# Product Change Notification

**Product Change Notification:** E-19-007253

MQS Tabellenzeichnung Buchsenkontakt TABLE SOCKET CONTACT

E-19-007253				
Product Engineering				
Document Clarification				
Yes				
C23				
MQS				
Tabellenzeichnung Buchsenkontakt				
TABLE SOCKET CONTACT

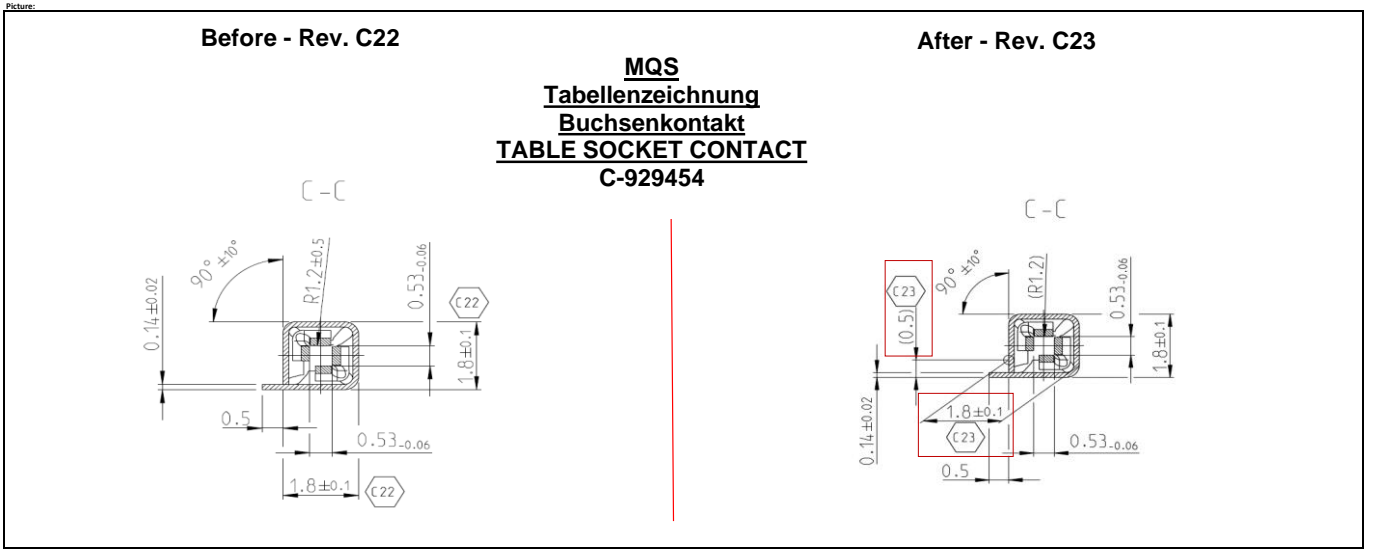
Definition of a measurement point for the contact height measurement, as the height definition was unclear. With the change we want to align measurements at customer side with the measurement within TE. The change in the measurement definition will be valid after 05th of June 2019.
